Re: Agnico Eagle's response to Meadowbank (2AM-MEA1530) and Whale Tail (2AM-WTP1830) 2020 Annual Report comments

- Nunavut Water Board – September 17, 2021: Licences No: 2AM-MEA1530, Meadowbank Gold Mine Project; 2AM-WTP1830, Whale Tail Pit Project; Agnico Eagle Mines Limited; 2020 Annual Report Review

Figure 3. Development and Application of Monitoring Thresholds and Triggers for Water Chemistry Variables

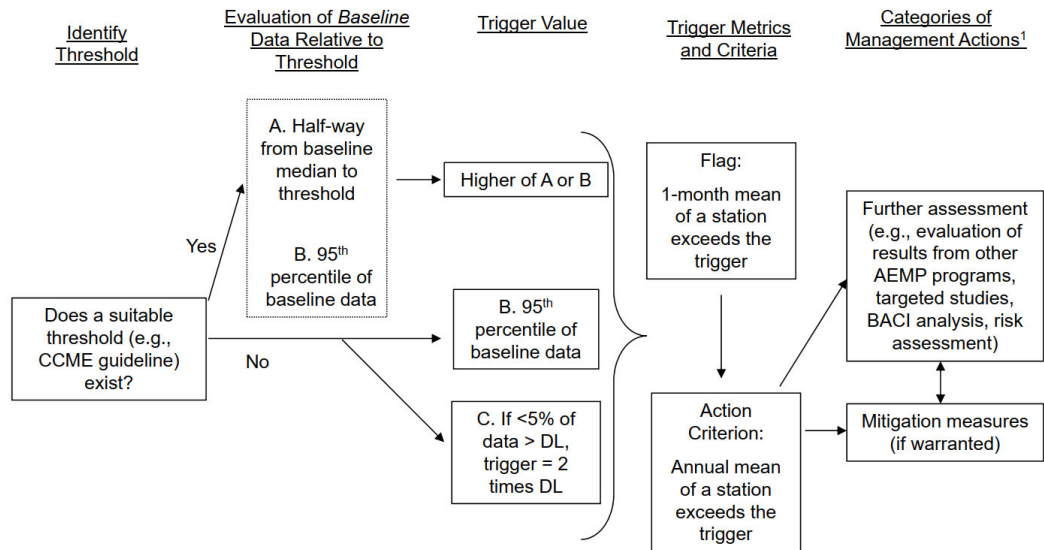
Recommendation 8: CIRNAC recommends that future Annual Reports: Use a modified reporting approach to ensure that comparisons between monitoring data and applicable criteria reflect the temporal and spatial variability inherent in these natural systems. Specifically, reporting should not be based solely on mean data for entire water bodies.

The approach to evaluating short-term changes in water quality was first outlined in the CREMP Design Document 2012 (Azimuth, 2012). As depicted in Figure 3 from that report (see below), individual samples are screened against the trigger values each month to determine if there are short-term changes in water quality linked to activities at the mine. The monthly screening assessment is meant to "flag" parameters for closer examination in subsequent sampling events. If a threshold exceedance is detected (i.e., water quality guidelines), and if the exceedance is plausibly linked to activities at the mine, the Environment Department is notified to provide advanced warning of potential changes in water quality. It is important to reiterate that changes in water quality need to be evaluated relative to predicted changes provided in the Environmental Impact Statements for each Project.

Figure 1: Comparison of total sulphur (wt%) for duplicate samples analyzed at SGS and Meadowbank labs

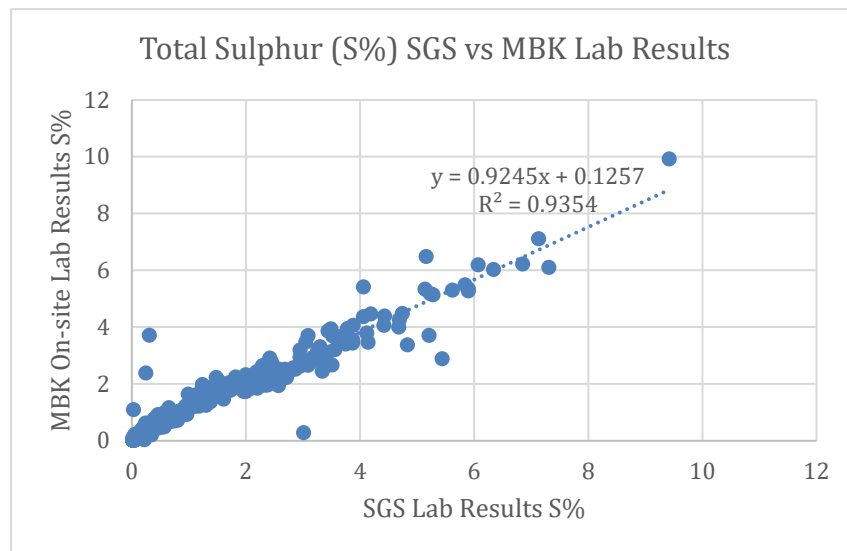
- ii) Provide the supporting evidence and statistical summaries of the geochemical data from the accredited external laboratory that were used to confirm that AEM's methodology and results used to differentiate PAG/NPAG rock are appropriate.

A comparison has been done on the 2020 laboratory results from samples that were sent externally to SGS for acid-based accounting analysis and corresponding duplicate samples that were analysed for total sulphur and inorganic carbon at the on-site lab at Meadowbank. Figure 1 shows the comparison between total sulphur content results from SGS and the Meadowbank labs. The correlation between total sulphur results between the two labs is strong. Section 3.2.1 of Appendix 21 – Whale Tail Operational ARD-ML Sampling and Testing Plan Version 6, states "Total sulphur will be used as an initial screening criteria to identify NPAG material, whereby a sample will be considered NPAG when it contains less than 0.1 wt% sulphur, regardless of the CaNP (Golder 2018). Where total sulphur is above 0.1%, the calculated carbonate CaNPR value will be used for sample classification." Therefore, on the basis of sulphur content alone, the methodologies are consistent between the two laboratories.
